APPLICATION NO.	FILING DATE	FIRST NAMED INVENTOR	ATTORNEY DOCKET NO.	CONFIRMATION NO.
10/750,400	12/31/2003	Joakim Gripemark	03370-P0068A	8989
24126	7590	02/14/2006	EXAMINER	
ST. ONGE STEWARD JOHNSTON & REENS, LLC 986 BEDFORD STREET STAMFORD, CT 06905-5619			SY, MARIANO ONG	
			ART UNIT	PAPER NUMBER
			3683	
DATE MAILED: 02/14/2006

Office Action Summary	Application No.	Applicant(s)	
	10/750,400	GRIPEMARK ET AL.	
	Examiner	Art Unit	
	Mariano Sy	3683

DETAILED ACTION

Fig. 3

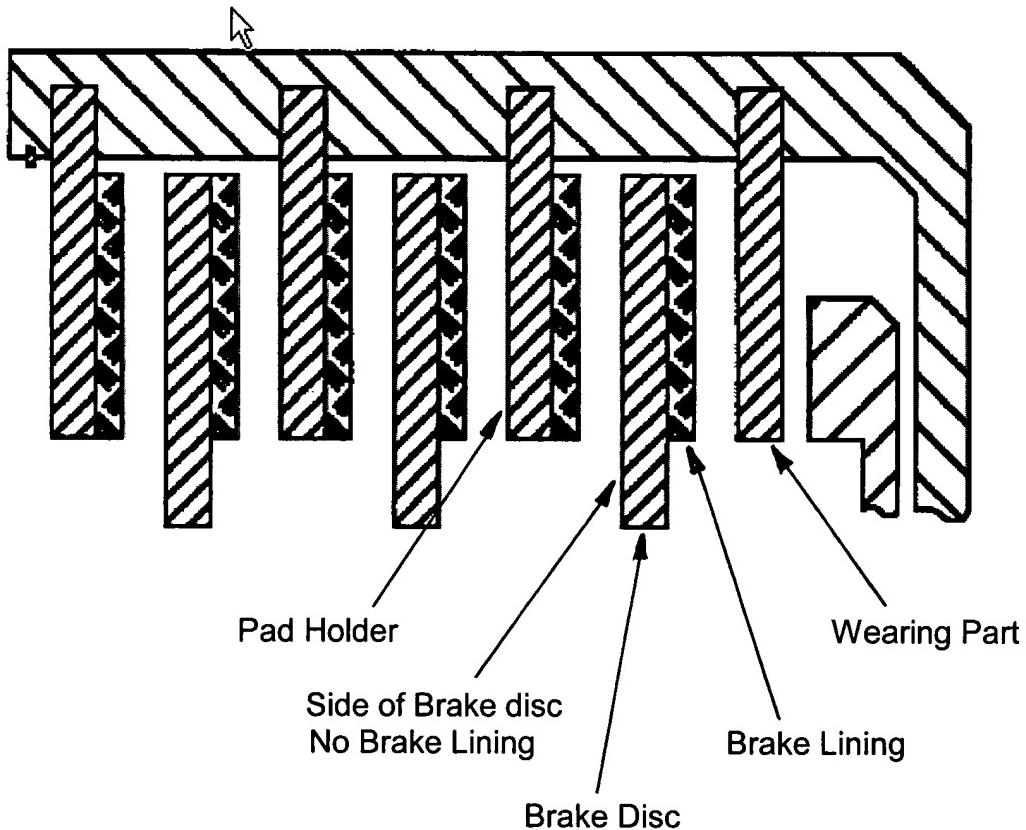
Note the clutch, which is functionally equivalent to a disc brake, having a caliper (see fig. 3 and 4) with a disc having a brake lining material on one side and that there is no brake lining material on the other side of the disc, wherein wearing part (shown as the last part to the right end attached to the caliper) is placed in the caliper for contact with the brake lining material of the disc during braking, and pad holder (left hand

direction of the brake disc) is arranged on the side of the brake disc having no brake lining.

10. Examiner maintains Takakura et al. (US 5,975,267) still reads on amended independent claim 1 and new independent claim 11. See attached Fig. 3 below. The pad holder is arranged on the side of the brake disc having no brake lining.
